RE: **PUBLIC** Comments of the Minnesota Department of Commerce
Docket No. E002/M-25-142

In the Matter of Xcel Energy's 2025 Integrated Distribution Plan.

Xcel Energy's (Xcel or the Company) Integrated Distribution Plan (IDP) was filed on October 31, 2025. Xcel's Transportation Electrification Plan was filed concurrently.

Figure 2: Comparison of Xcel Spending Over Time

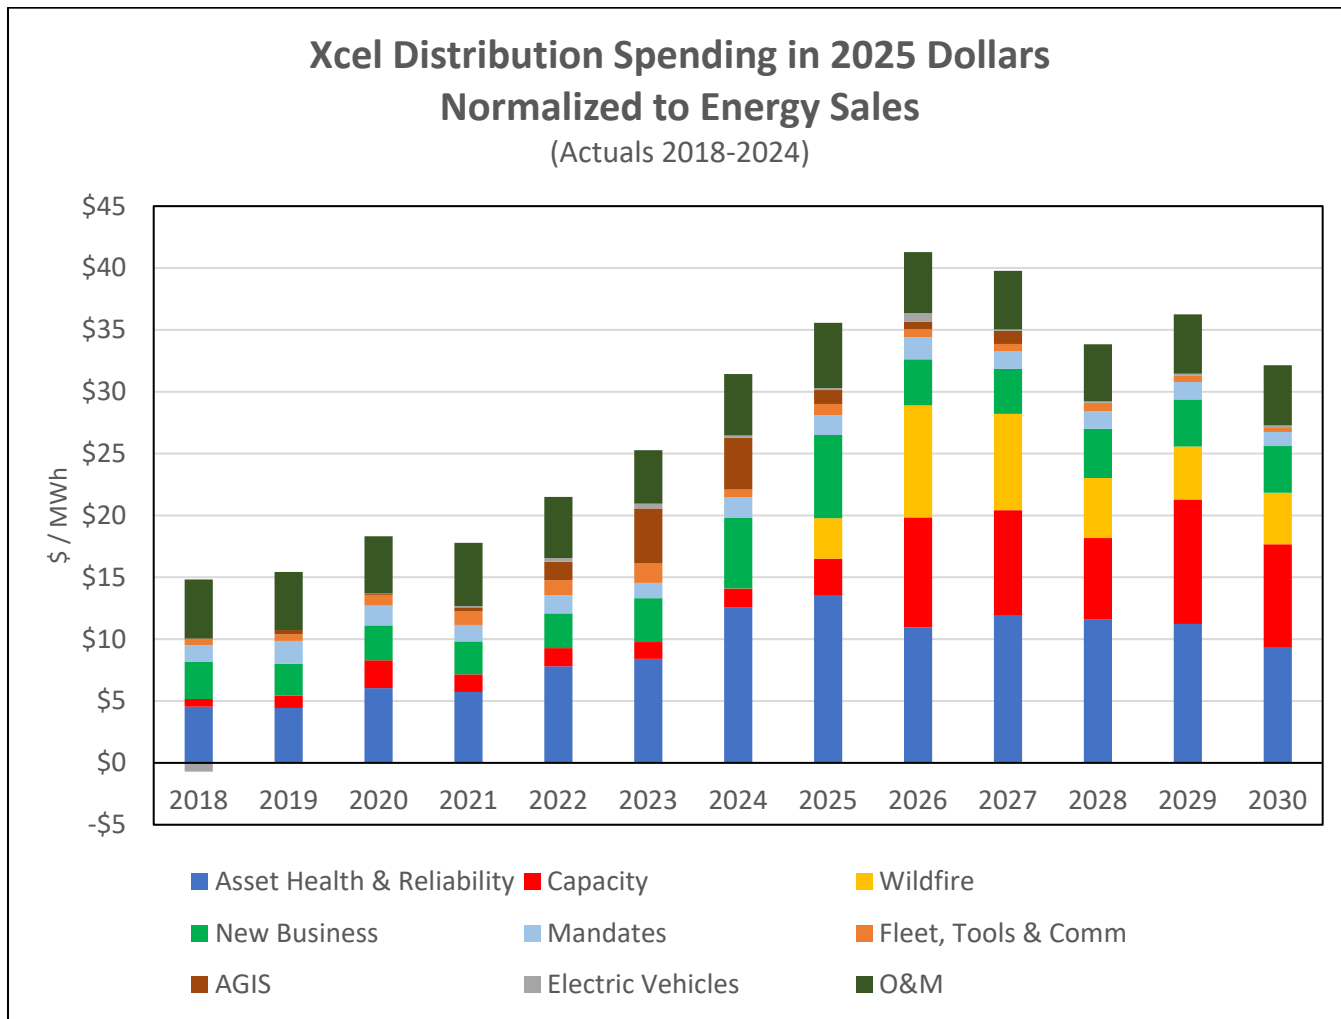
While the data on total capex spending provides a compelling argument for enhanced scrutiny of Xcel's distribution plan, increases in spending are most meaningful in the context of rates. To this end, the Department compares seven years of historical distribution (2018-2024) spending to Xcel's forecasted spending in this IDP (2025-2030) in Figure 2. The data is normalized to 2025 dollars and to distribution energy sales, which controls for inflation and actual changes to sales, and therefore impacts to customer bills. Figure 2 shows a clear trend that Xcel's distribution spending doubled between 2018-2019 and 2024, and Xcel's forecasted distribution budget is expected to remain well over double the 2018-2019 level in its forecasted distribution budget period. In addition, these increases in spending are not expected to be mitigated by new energy sales, at least in the near-term. These data support the data presented in Figure 1, which leads the Department to conclude that Xcel's distribution spending is significantly impacting rates. Finally, Xcel provides its own data to support a similar conclusion. Xcel reports that its distribution revenue requirements are expected to increase from \$468,404,000 in 2021²² to \$1,048,136,000 in 2030.²³

While distribution spending now makes up a large share of total utility capex spending and rates, there is essentially no secondary process to ensure that Xcel optimizes its distribution spending, as there is in an integrated resource plan (IRP) or in the Midcontinent Independent System Operator (MISO) transmission planning process. In an IRP, or in MISO’s transmission planning process, optimization occurs to ensure that the least cost additions are made to the system. No such optimization exists for distribution investments. The current implementation of IDPs does not prove that the distribution system has been optimized. Given the significant share of utility spending on distribution investments, the Commission’s Planning Objectives must be operationalized to create this process for distribution, particularly objectives 4 and 5. Actual spending, shown in Figure 2, demonstrates that the existing IDP and rate case processes have not succeeded in preventing Xcel’s distribution budget from doubling in

Figure 4: Xcel Presentation of Mandatory VS Discretionary Spending

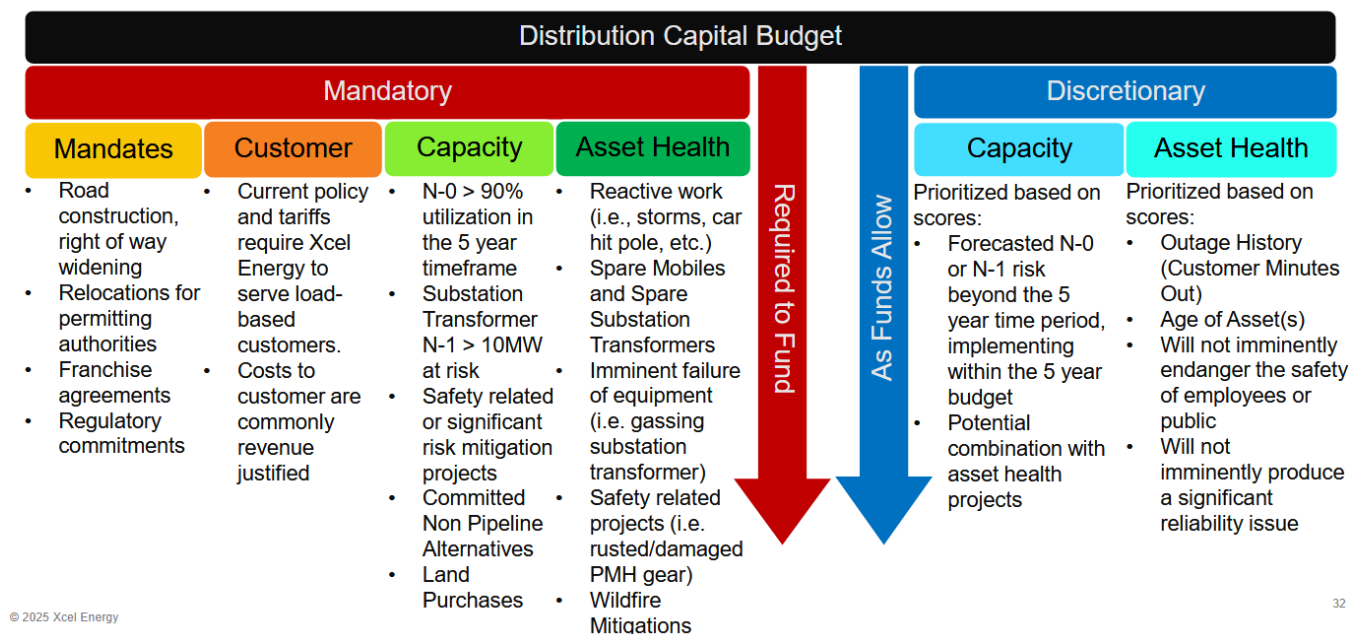
Xcel may counter that large portions of its system planning are not discretionary (Figure 4), which implies that these projects do not require optimization. While the Department does not question the validity of some mandatory spending shown in Figure 4, the Department disagrees on Xcel’s use of the term “mandatory.” Upstream decision making before budgeting, such as decisions made in forecasting, capacity planning limits, the benefits of reliability, and wildfire mitigations all involve judgment and choice. As the Department will demonstrate in these comments, there is a strong need to evaluate whether Xcel’s system planning decisions are in the public interest.

Figure 6: Comparison of Actual Feeder Capacity to Xcel’s N-0 Capacity Planning Standard

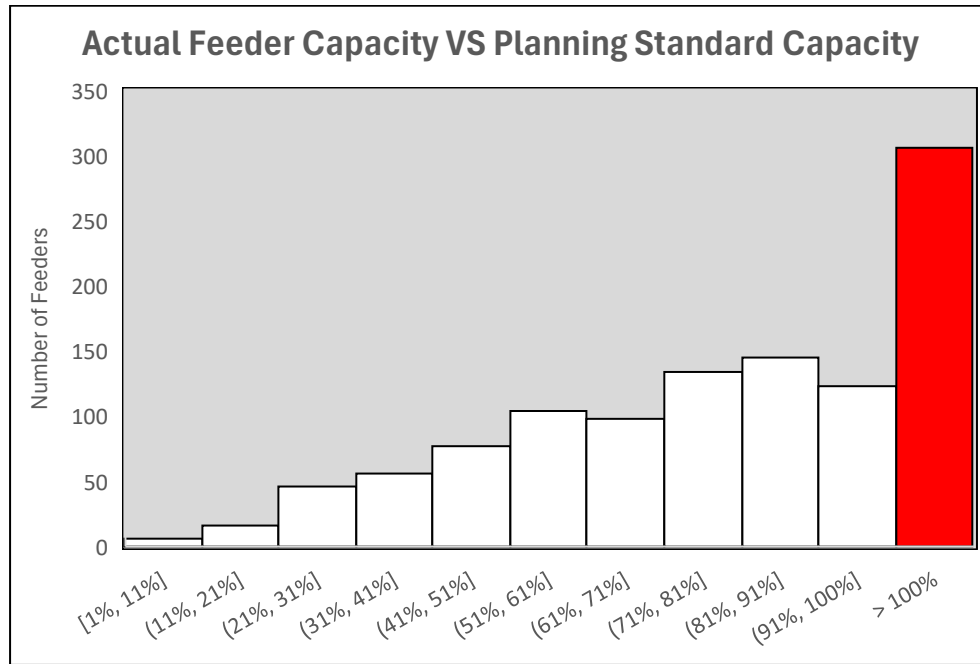
While Xcel may argue that these planning standards cannot be modified, these assertions are easily refuted by Xcel’s own data. Figure 6 shows that 27 percent of Xcel’s existing feeders are currently exceeding Xcel’s planning standard, which indicates that the Company decided to not fully enforce its own planning standards.

Figure 8: Xcel’s Wildfire Budget Adjusted to Energy Sales

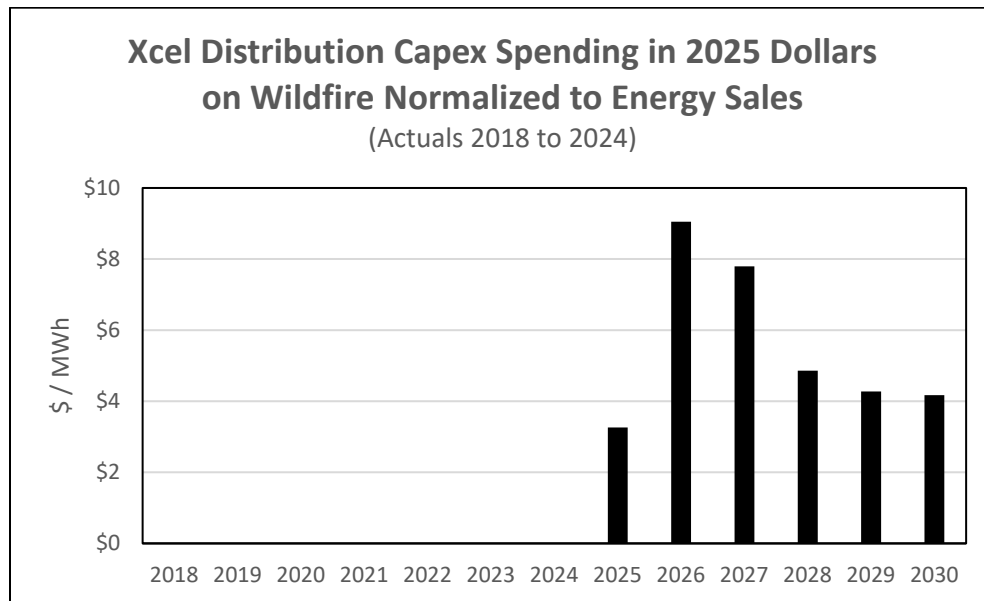
Xcel’s wildfire spending is also expected to rise from zero to a spending level on par with that of Xcel’s capacity budget, which is shown in Figure 8. Together, these two budgets account for 41.6% of Xcel’s total capex budget between 2025 and 2030, and both budgets are rising at alarming rates.

Figure 17: Number of Feeders That Exceed the 75% Capacity Planning Standard: 2019–2029

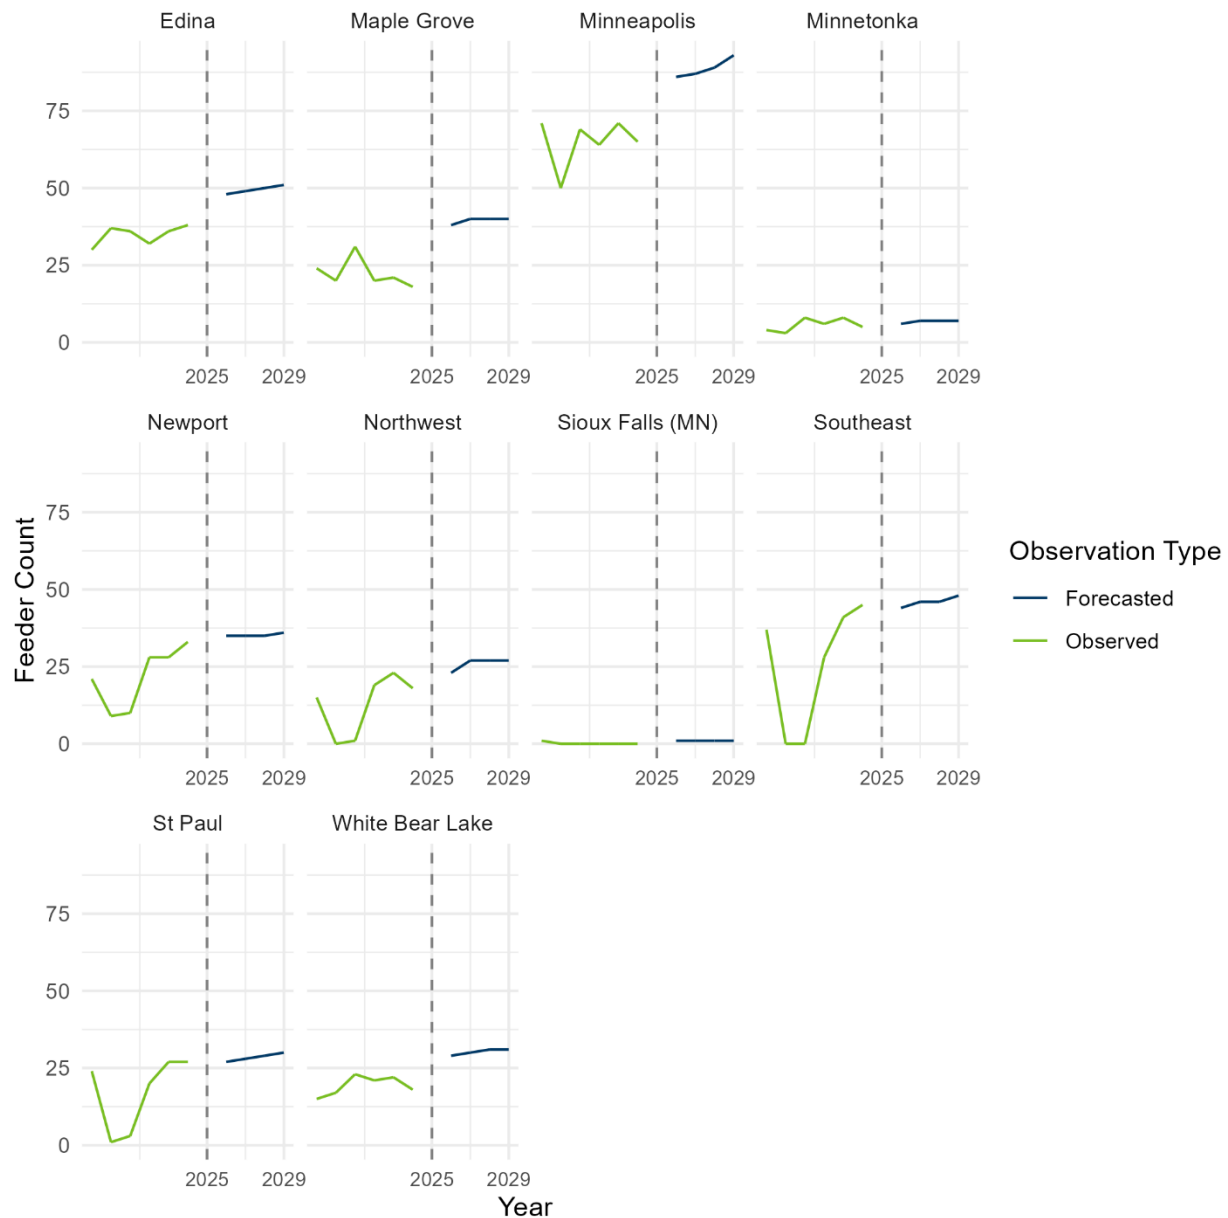
disaggregated by Planning Division. This figure indicates that capacity constraints are not evenly distributed across the system; certain PDs consistently exhibit higher numbers of heavily loaded feeders.

These patterns raise important questions about the underlying causes of forecasted rise in feeder congestion and whether capital investments are efficient. While most planning divisions show observable trends in Figure 17, Edina, Maple Grove, Minneapolis, and White Bear Lake all show visible

Figure 19: Projected Increase in Heating Load by Planning Division

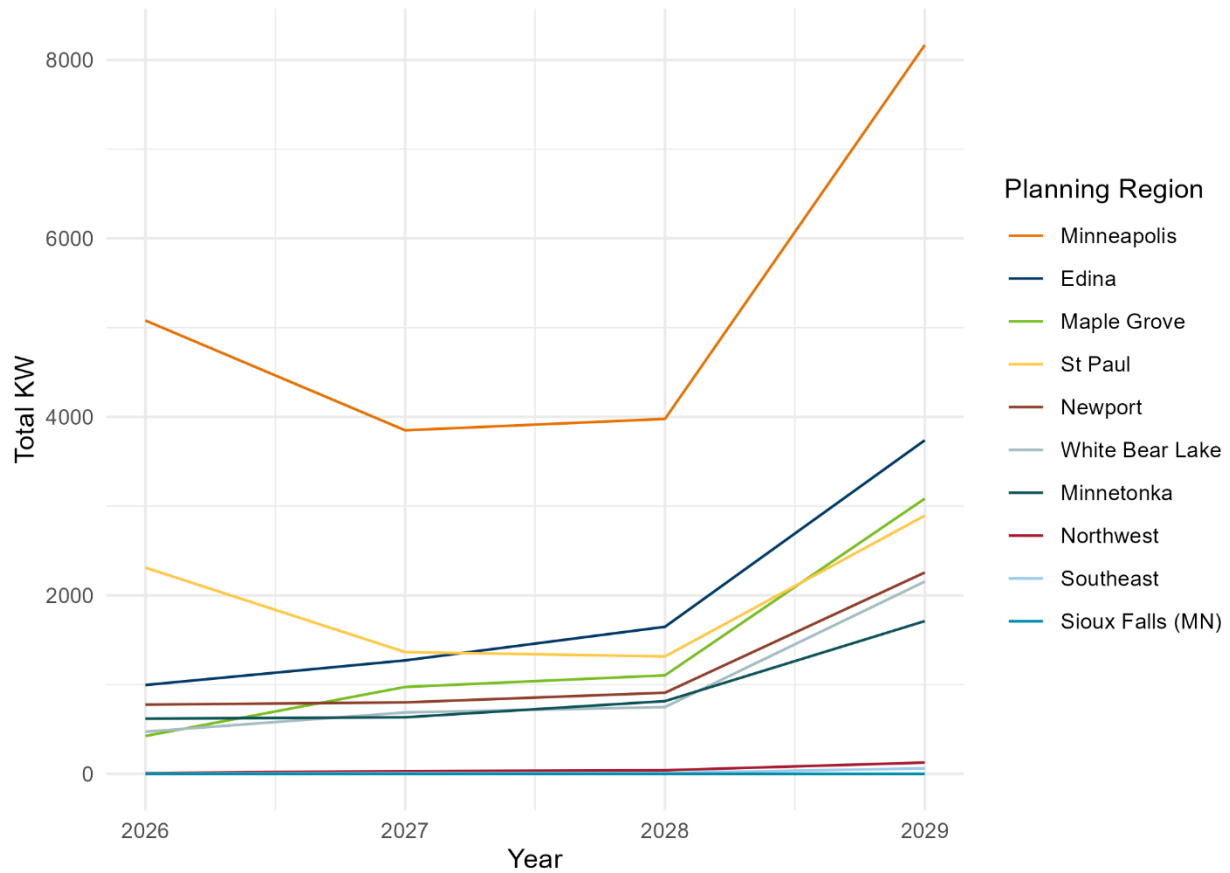
For example, in Minneapolis, forecasted heating-related peak load is projected to approximately double within a two-year period. Similarly, EV-related peak load increases sharply in multiple PDs over the forecast horizon. While electrification is an expected long-term trend, the magnitude and timing of these increases raise questions about the underlying assumptions driving the Company’s forecasts.

Figure 20: Projected Increase in EV Load by Planning Division

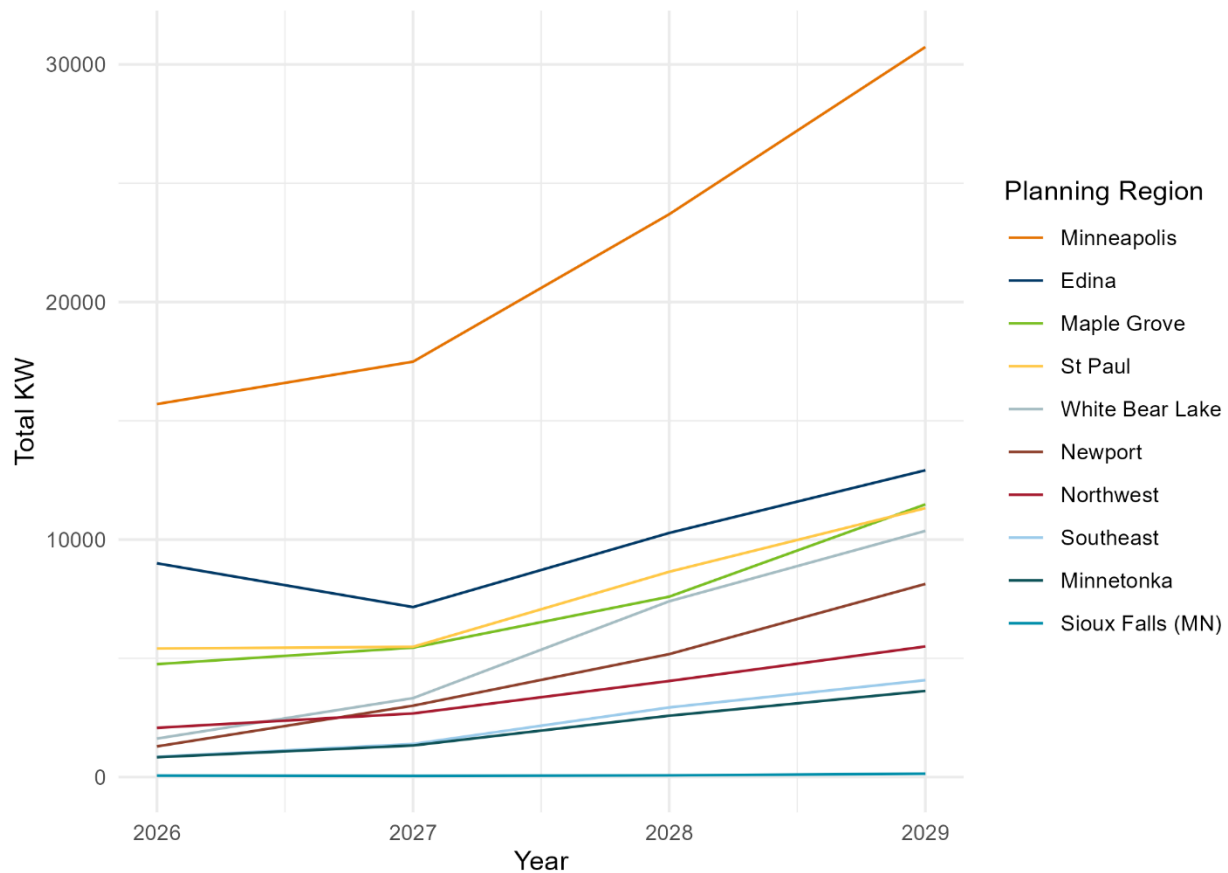
In particular, the Department is concerned that projected peak load growth may be driven by optimistic assumptions regarding the pace of technology adoption rather than by empirically observed trends. Recent historical data on heat pump installations, EV adoption, and customer load shapes generally show more gradual uptake, influenced by factors such as equipment costs, building stock turnover, consumer preferences, and infrastructure constraints.⁷² The Company’s forecasts appear to assume rapid and widespread adoption over a short period without clearly demonstrating that such adoption rates are consistent with observed customer behavior in each Planning Division.

Figure 24: Actual Feeder Loading Compared to Rated Capacity

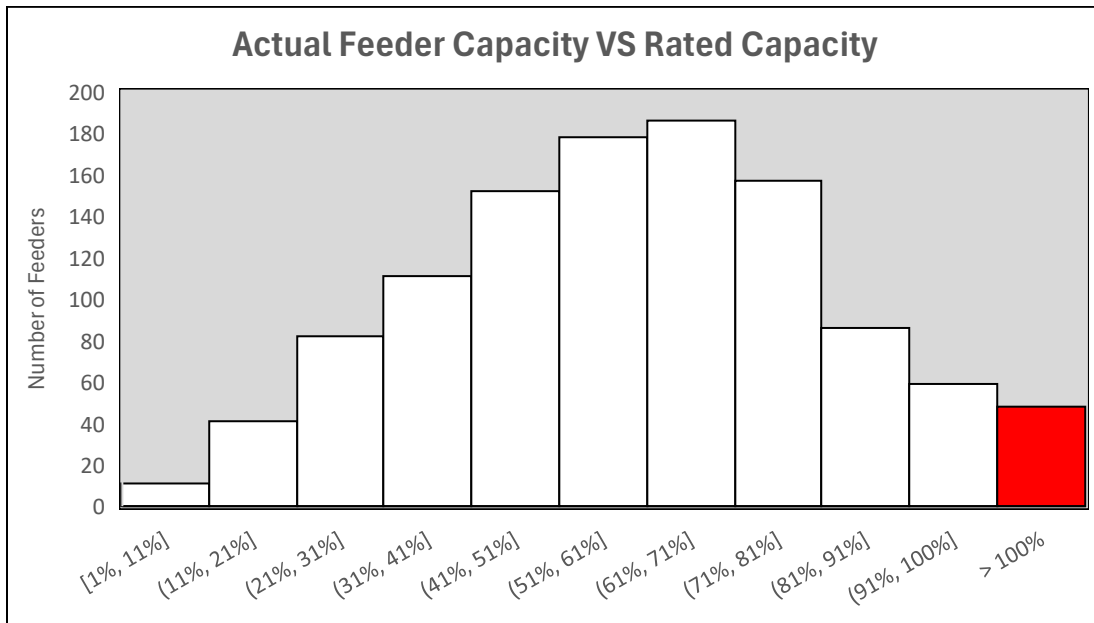
Xcel’s feeder capacity data reflects a similar pattern, where 3.2% of feeders are currently overloaded, as shown in Figure 24.
